# HOLGATE 12 APARTMENTS II

2nd EARLY DESIGN GUIDANCE

180812TH AVE. S.  
PROJECT # 3018185

JANUARY 27, 2015

OPTION E; Courtyard, Modulation to save Deadora Cedar

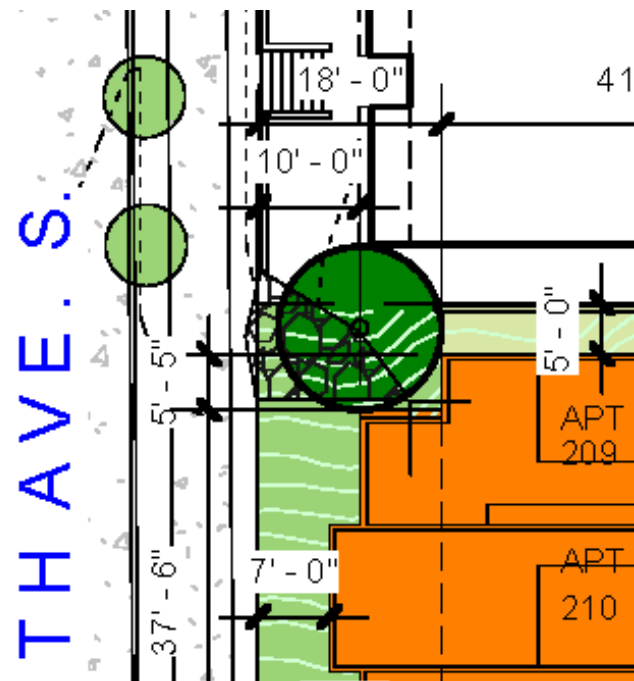
The Board agreed that the retention of the northwest tree is important and discussed that the design for the northwest portion of the building façade needs to respond to the siting of the northern building.

*The front of the building has been modulated to create a space to save the tree which is about equal to the existing space. The rockery that the tree is growing in will also be preserved. The base of the existing tree is above the sidewalk by about 6 feet. In order to create a pedestrian amenity at sidewalk level an alternative street tree is proposed to replace the Deadora Cedar with another conifer (Serbian Spruce) at sidewalk level. This alternative tree is selected to be more suitable to the space under the power lines. With this alternative a bench could also be added to the space.*

- Option E preferred (Courtyard) : Yes Saved Tree*
- Option F (No Courtyard): Yes Saved Tree*
- Option G (townhouse): Yes Saved Tree*

OPTION E (preferred) Modulations

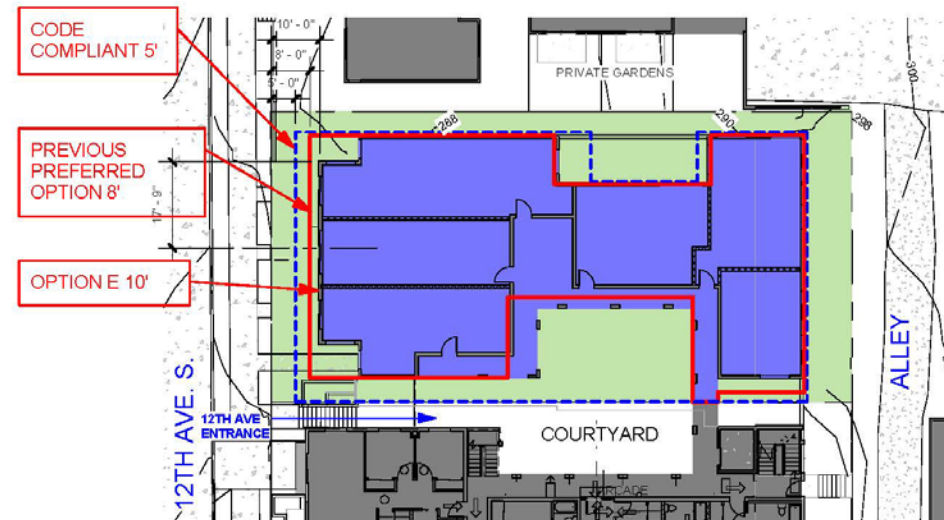
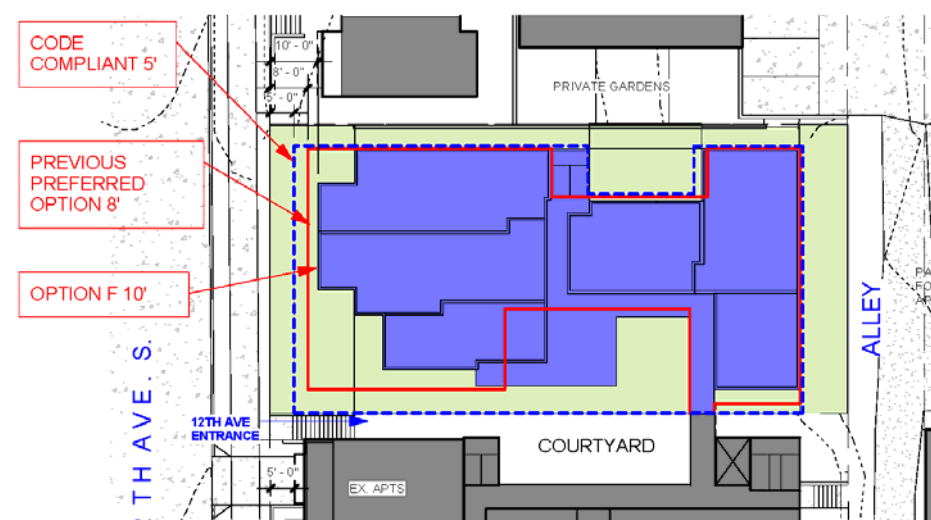
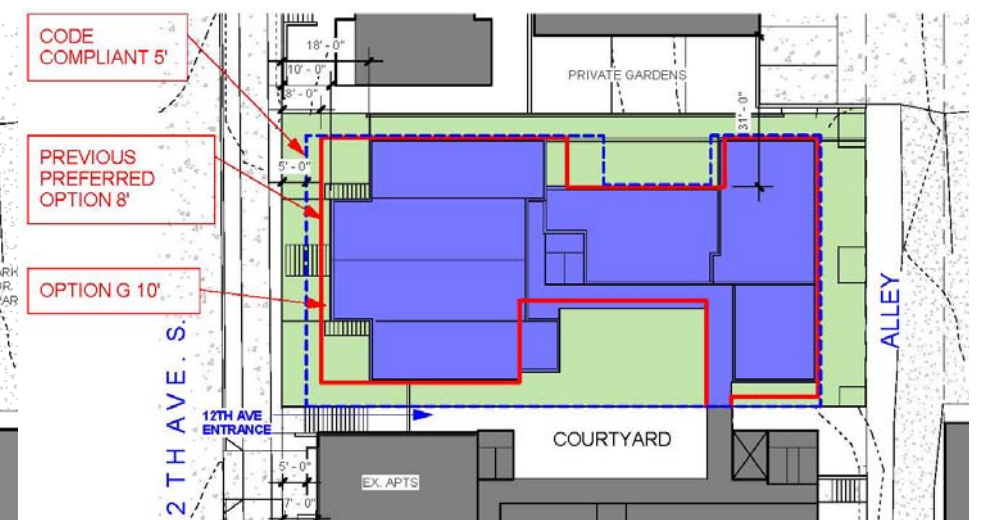
a. The Board recommended modulating the building, while keeping a strong residential street edge at the first floor. (CS2-B, DC2-A, DC2-D, DC2-E)

*Vertical Modulations of about 6'-7' wide and 8' deep have been added in preferred Option E. 12' wide x 8' deep added in Options G in both the NW and SW corners and about a 7' wide x 7' deep in the NW corner and 2 modulations one 5' wide and 8' deep modulation in Option F. Option F also has an additional 11' wide & 6' deep modulation in the SW corner on the 2<sup>nd</sup> level.*

*These modulations add to the visual separation between the proposed addition and the Townhouses to the North and the Existing Building to the South to meet DC2-A2 to reduce the perceived mass of the building. These modulations also create open space for saving the existing Deadora Cedar Tree and for a new public entrance at 12<sup>th</sup> Ave S. into the Basement Level of the building.*

*The Majority of the Front façade has been setback further from 8' in the previous Options to 10' to be about the same setback for the upper levels of the Townhouse to the North.*

OPTION E; Courtyard, 26 units (preferred)

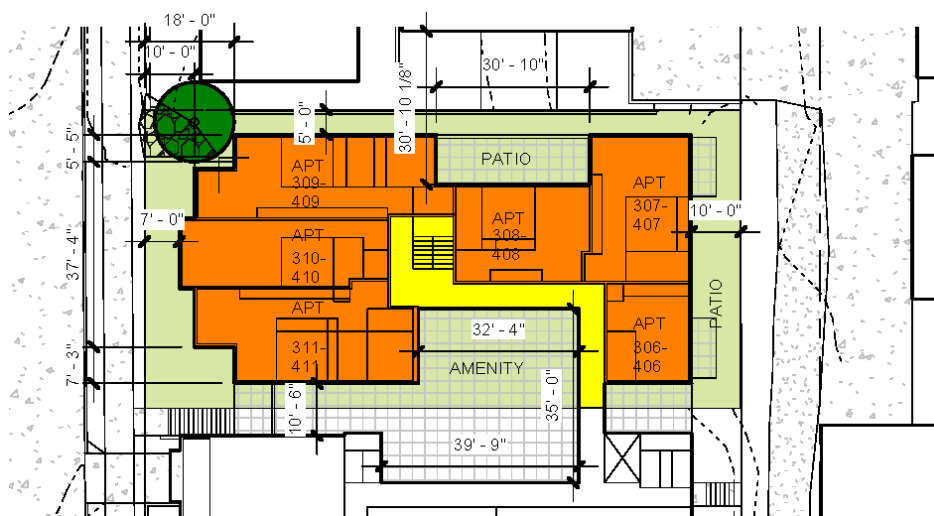
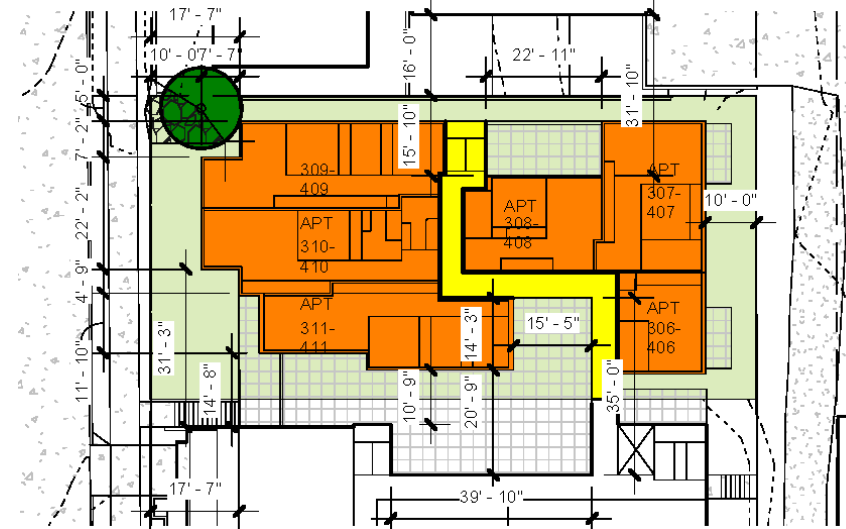
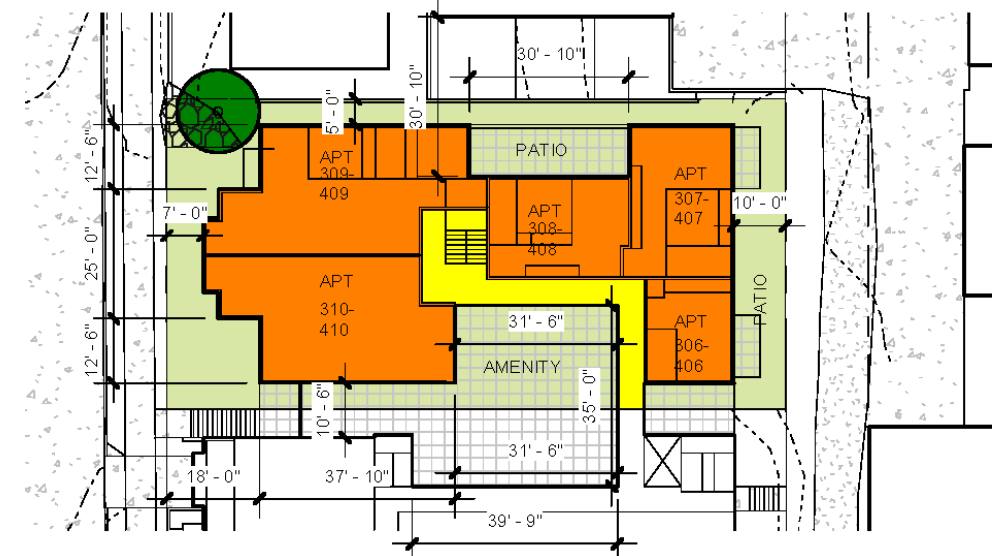
The Board discussed the limited courtyard and deck options shown.

*An additional Courtyard Option F has been developed to show another option of locating most of the open space at the front and the south side of the building. This Option does not meet the Design Guidelines DC3-C for the open space to connect to or enhance other existing open spaces in the existing building to the South and the private Gardens to the North as well as Options E & Option G.*

*Option E (Courtyard) : Yes connects and enhances other existing open spaces.*

*Option F (No Courtyard) : No does not connect or enhances other existing open spaces.*

*Option G (Townhouse) : Yes connects and enhances other existing open spaces.*
